**BEFORE THE NORTH CAROLINA UTILITIES COMMISSION  
DOCKET NO. E-2, SUB 1219**

**Application of Duke Energy Progress ,  
LLC for Adjustment of Rates and  
Charges Applicable to Electric Service  
in North Carolina**

) **TESTIMONY OF DENNIS**  
) **STEPHENS ON BEHALF OF THE**  
) **NORTH CAROLINA JUSTICE**  
) **CENTER, NORTH CAROLINA**  
) **HOUSING COALITION, NATURAL**  
) **RESOURCES DEFENSE COUNCIL**  
) **AND SOUTHERN ALLIANCE FOR**  
) **CLEAN ENERGY AND THE**  
) **NORTH CAROLINA**  
) **SUSTAINABLE ENERGY**  
) **ASSOCIATION**

**April 13, 2020**

*Figure 1: Relationship between Grid Investment and Reliability for DEC*

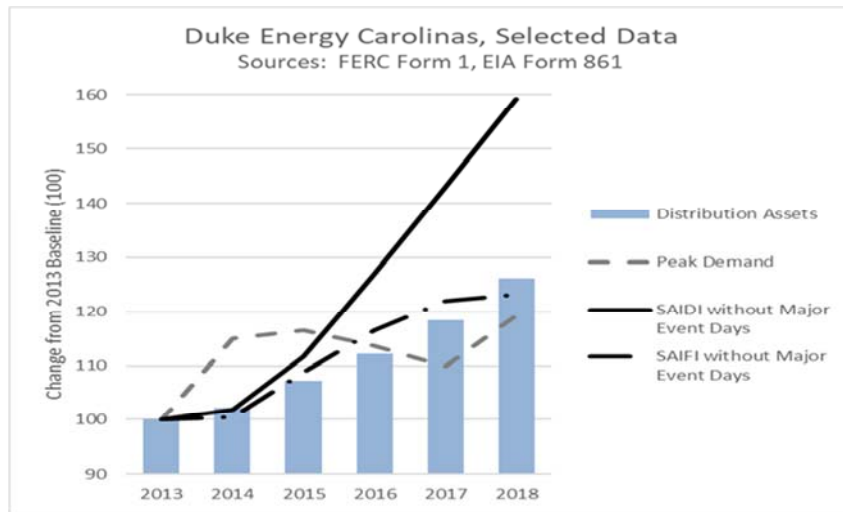
1           As shown in Figure 1, DEC's SAIDI and SAIFI performance have  
2           deteriorated almost 60% and more than 20%, respectively, since 2013 despite grid  
3           investment growth 37% greater than peak demand growth. As shown in Figure 2,  
4           DEP's SAIDI and SAIFI performance have deteriorated almost 50% and more  
5           than 5%, respectively, since 2013 despite grid investment growth 61% greater  
6           than peak demand growth.

*Figure 2: Relationship between Grid Investment and Reliability for DEP<sup>9</sup>*

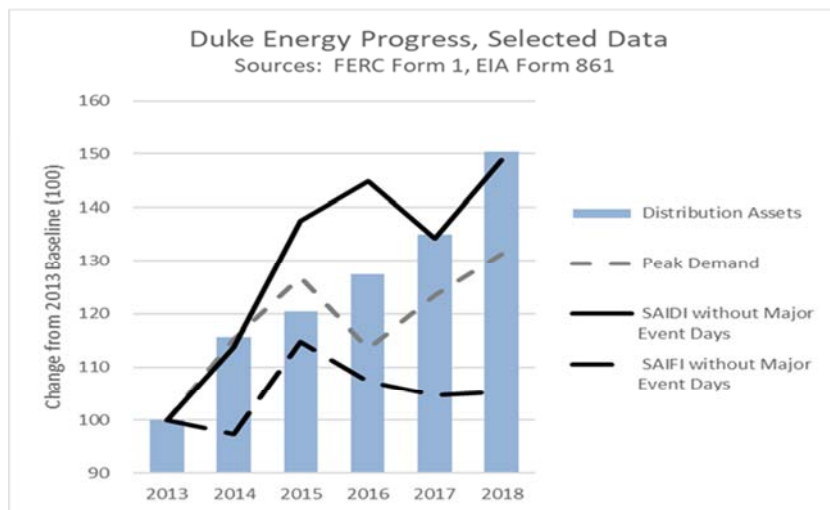
<sup>9</sup> As referenced above, DEC and DEP are each presenting the GIP program for approval in their respective concurrent rate cases. To that end, I have included DEC and DEP analysis here as it supports my point that historical investments do not correlate with SAIDI and SAIFI improvements. I believe this is a key indictment of the GIP.
